Report to the Future Melbourne (Planning) Committee

**Ministerial Planning Referral: TPM-2020-54
77–83 Sutton Street, North Melbourne****3 August 2021****Presenter:** Larry Parsons, Head Statutory Planning**Purpose and background**

MINISTERIAL PLANNING REFERRAL

Application number:	TPM-2020-54
Applicant / Owner / Architect:	77-83 Sutton Street Pty Ltd / BEG Developments Pty Ltd / Point Architects
Address:	77-83 Sutton Street, North Melbourne
Proposal:	Construction of a twelve-storey buildings plus basements and a reduction of car parking requirements
Cost of works:	\$45,000,000
Date received by City of Melbourne:	1 July 2020
Responsible officer:	Marjorie Kennedy, Manager Statutory Planning

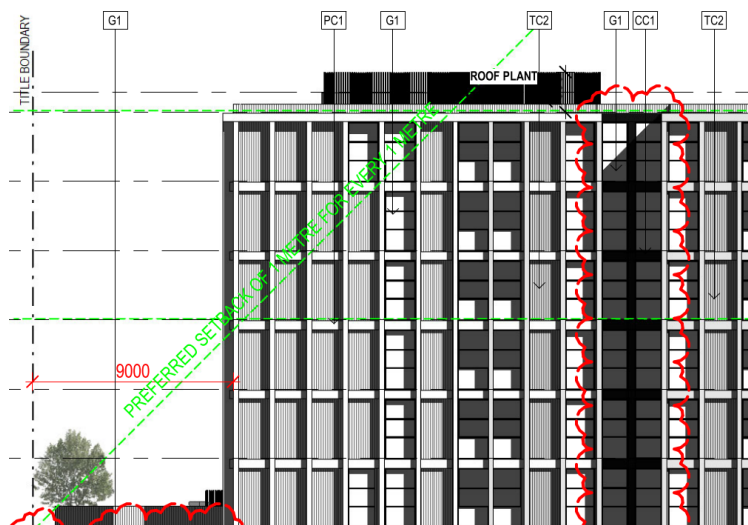
The proposed 6 storey podium height also responds to the height of the western adjacent heritage building as demonstrated in the streetscape elevation below.
